Product /Process Change Notification

PCN Number:PCN-20220117

1. Change Type:Add additional manufacturing site (Lite-On Thailand factory) of HP4 package

2.Parts Affected or Product Description: HP4 package – LTV-24X series

HP4 package – LTV-24X series

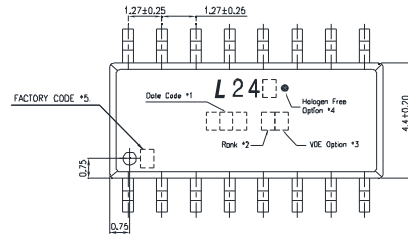
Lite-On uses identical materials all 3 factories Thailand, Tianjin and Changzhou site

Factory identification mark shall be marked (No marking: China - Tianjin / Changzhou, Y: Thailand)
